8. COA-045479-2018

3317 Monument Avenue

STAFF REPORT

Construct a new carport.

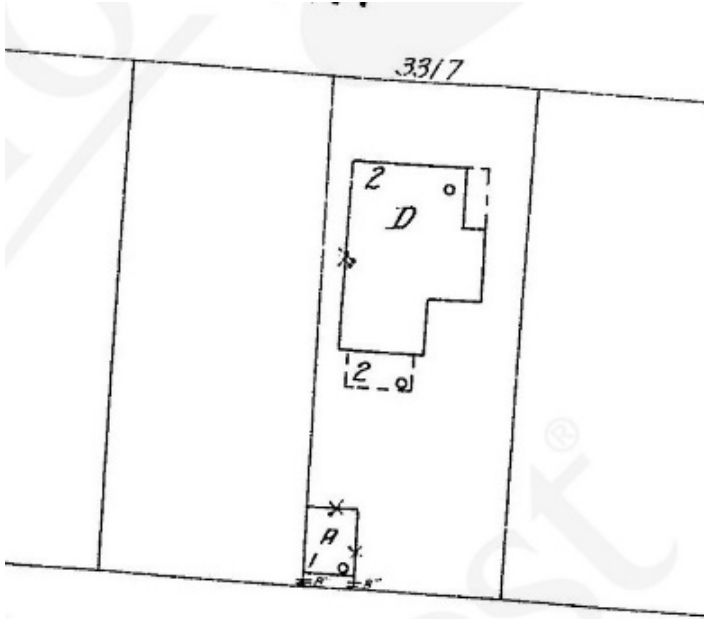
Window Maintenance #1, pg. 69	<i>Retain all original windows.</i>	The plans note that the window in the garage will be replaced with an aluminum clad window. As additional details regarding the condition of the existing window were not provided, <u>staff recommends a window survey be submitted to staff for administrative review to determine if the window is beyond repair. If the window is not beyond repair, it should be repaired and retained.</u>

- The garage door enclosure be revised to read as a garage door, rather than the proposed mix of materials. The revised design be submitted to staff for administrative review and approval. Proposed colors also be submitted to staff for administrative review and approval.
- A window survey be submitted to staff for administrative review to determine if the window is beyond repair and the window be retained if it is not beyond repair.
